WATER QUALITY M E M O R A N D U M

Utah Coal Regulatory Program

RE: 2009 3rd Quarter Water Monitoring, Canyon Fuel Company, Soldier Canyon Mine, C/007/0018, WQ09-3, Task ID #3388

G-5: D-Mg, Carbonate vs. Time

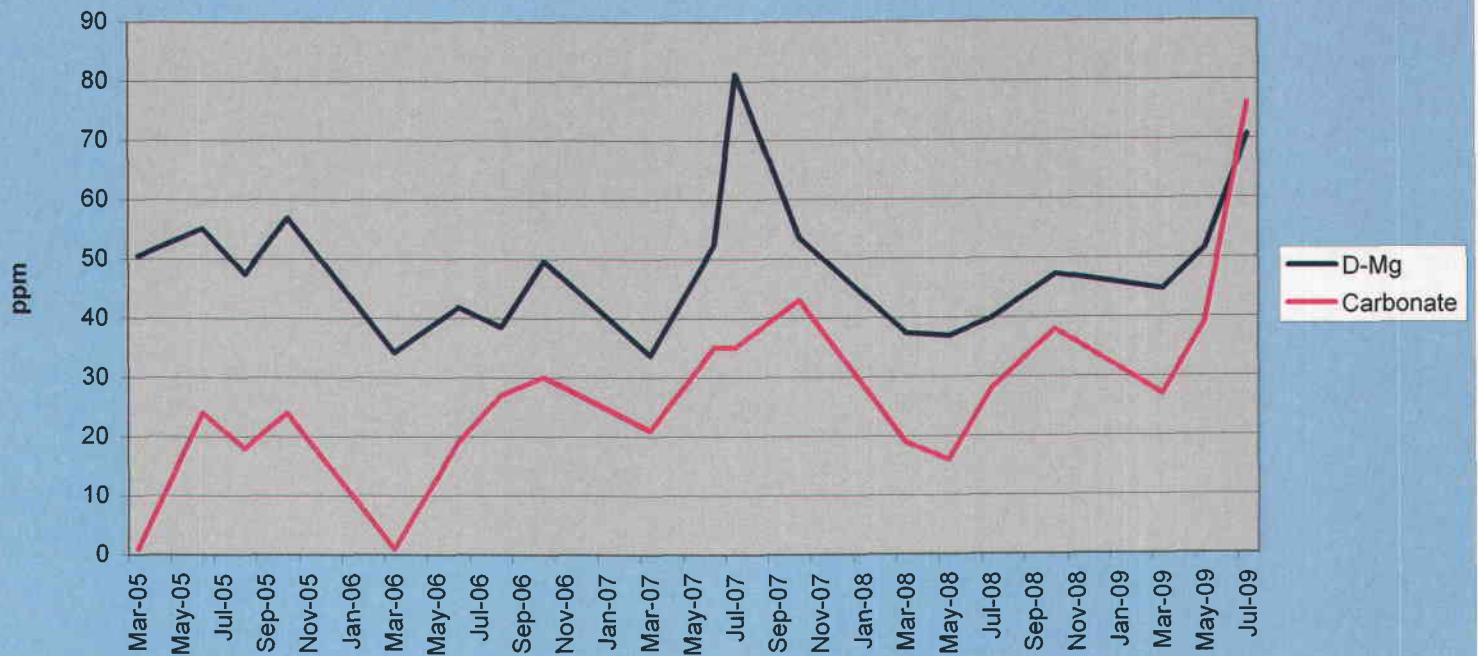
Dissolved Magnesium (D-Mg) and Carbonate (Carb) were reported outside of two standard deviations from the mean for surface water monitoring site G-5. Based upon the data, the increases in D-Mg and Carb that were reported this quarter appear to follow seasonal trends. It's likely that the higher D-Mg and Carb concentrations correspond to the seasonal increase in frequency and intensity of rainfall events during this time of the year. (See Charts Below).

TDS vs. Time

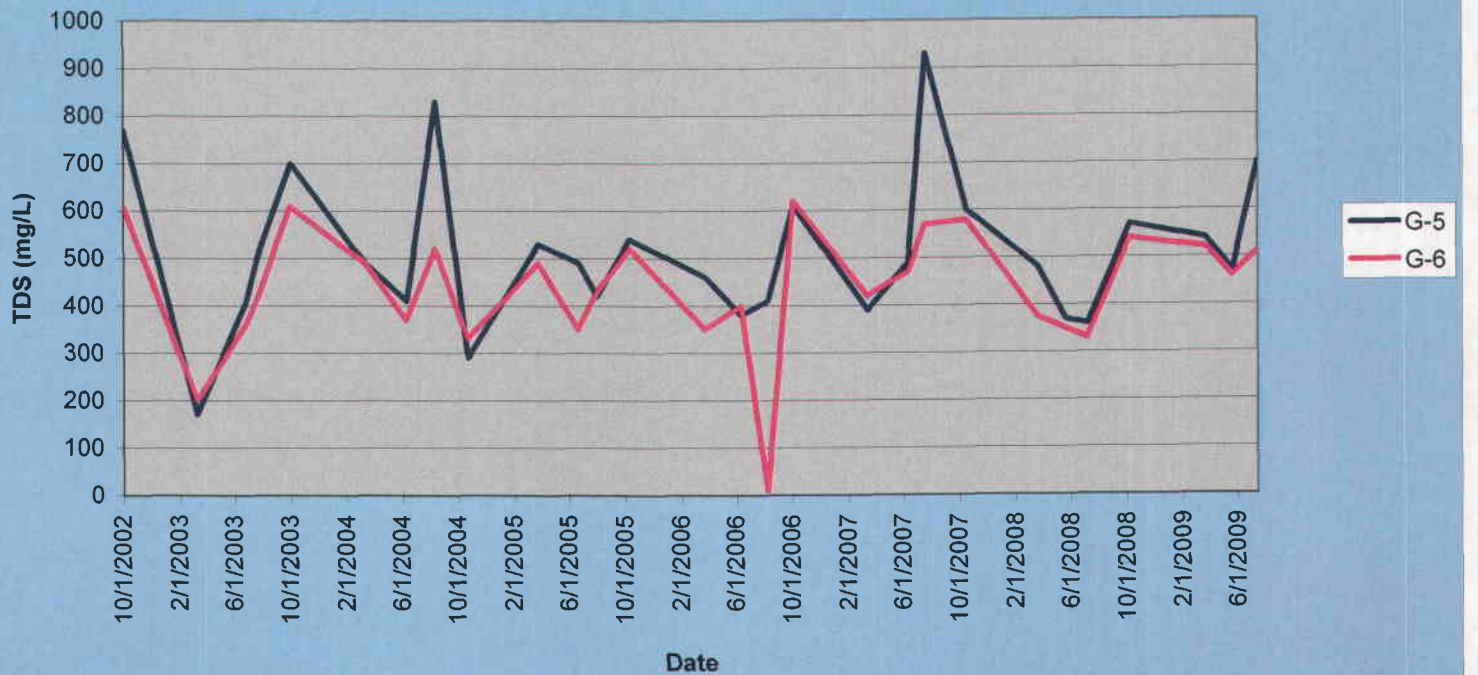
TDS values for both G-5 and G-6 continue to trend well below the 3,000-mg/L value as established by Rule R317-2 Standards of Quality for Waters of the State. For this quarter, G-5 and G-6 produced TDS levels of 700 mg/L and 510 mg/L respectively

Continue to monitor trends in TDS and it's components.
